**Subject:** RE: Gart\_LG\_IDOT

We have reviewed the exhibits and revisions forwarded via email and have the following additional conceptual comments.

**RIGHT TURN LANE ACCESS**  
**LONG GROVE SENIOR CARE**  
**ILLINOIS ROUTE 53**  
**LONG GROVE, ILLINOIS**  
**INTERSECTION SITE DISTANCE**

Prepared by: MLC  
 Checked by: MLC  
 Date: 7/17/2014  
 Job Number: 140314  
 Sheet Number: EXB-2

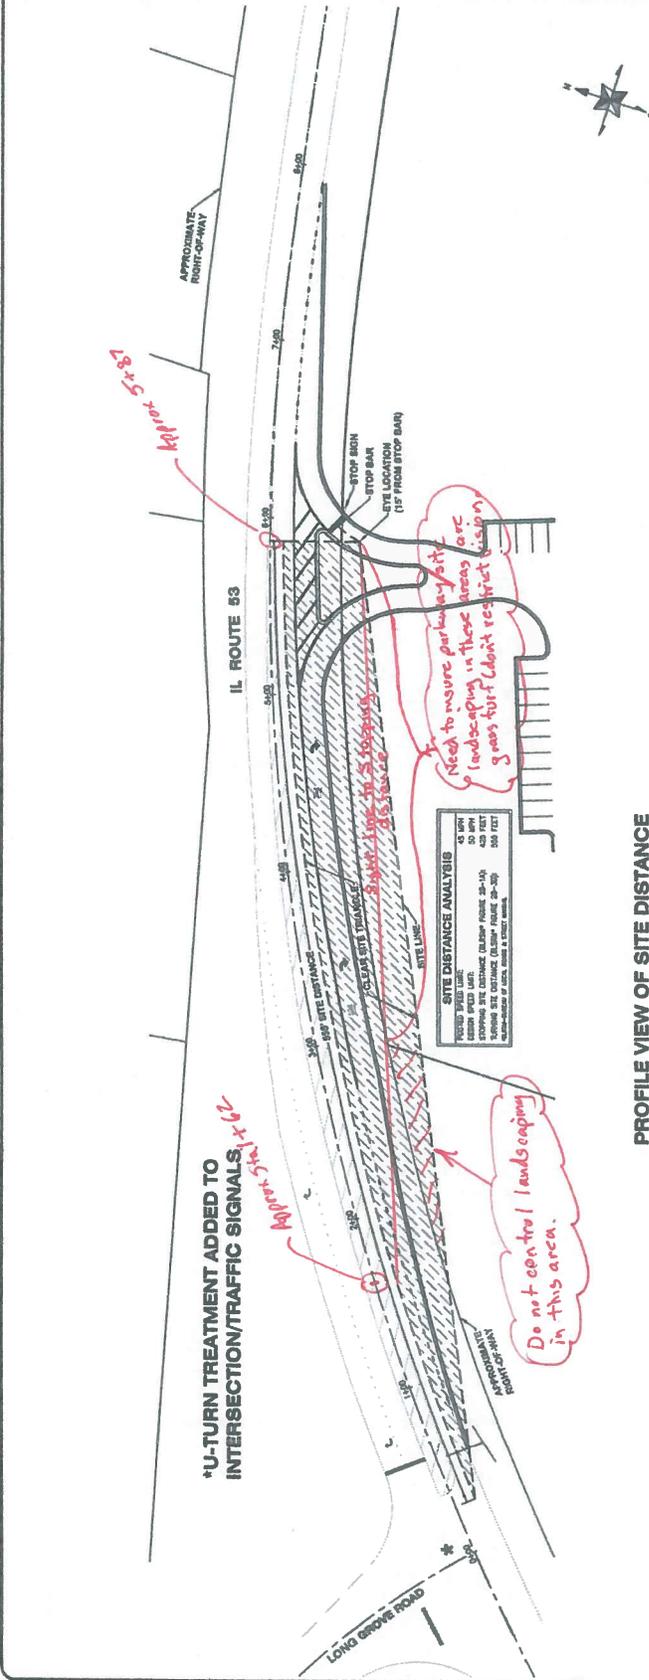
3. The sight and stopping distance exhibit is acceptable but should be revised to reflect the above revisions. Include the site line for stopping distance (shown in red on the attached) being careful to locate the access such that this site line crosses only your site's frontage and not the site to the west. Existing foliage or future landscaping on the site to the west (which you do not control) could obstruct site lines in the future, and adequate stopping sight distance sight lines should be insured at a minimum.
